TRANS/WP.29/2001/9
14 December 2000

PROPOSAL FOR DRAFT SUPPLEMENT 4 TO REGULATION No. 50

(Position, stop and direction indicator lamps for motorcycles)

Transmitted by the Working Party on Lighting and Light-Signalling (GRE)

"Front position lamps (for a pair of lamps)

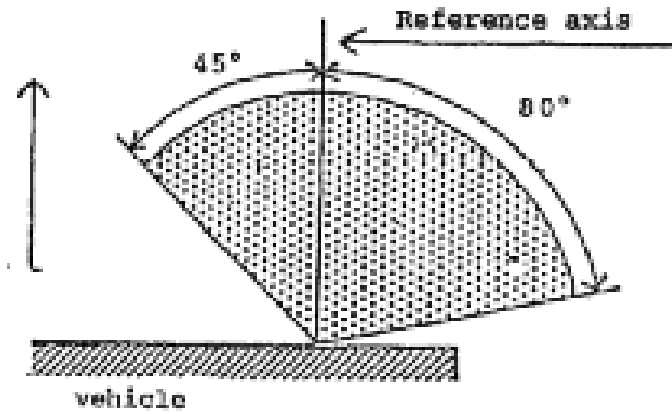
Paragraph 1., insert a new figure to read:

$$V = +15^\circ / -10^\circ$$

"Rear position lamps (for a pair of lamps)

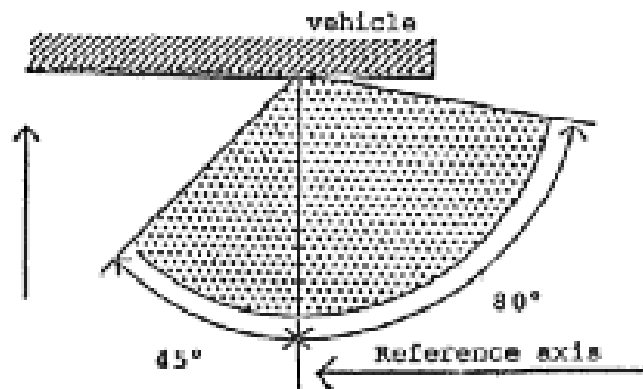
Paragraph 2., insert a new figure, to read:

$$V = +15^\circ / -10^\circ$$

"3. Direction indicators of categories 11, 11a, 11b, 11c and 12

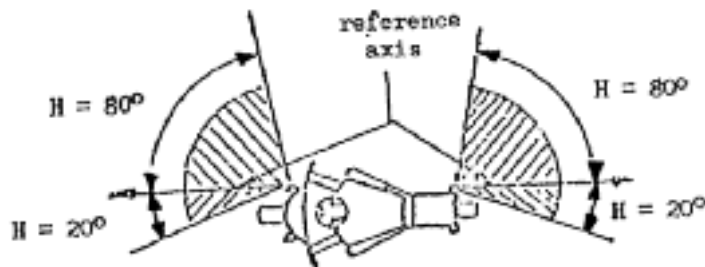
Paragraph 3., amend to read:

Minimum horizontal angles of light distribution in space:

$$V = \pm 15E$$

- Categories 11, 11a, 11b and 11c: direction indicators for the front of the vehicle;
- Category 11: for use at a distance not less than 75 mm from the passing beam headlamp;
- Category 11a: for use at a distance not less than 40 mm from the passing beam headlamp;
- Category 11b: for use at a distance not less than 20 mm from the passing beam headlamp;
- Category 11c: for use at a distance less than 20 mm from the passing beam headlamp.
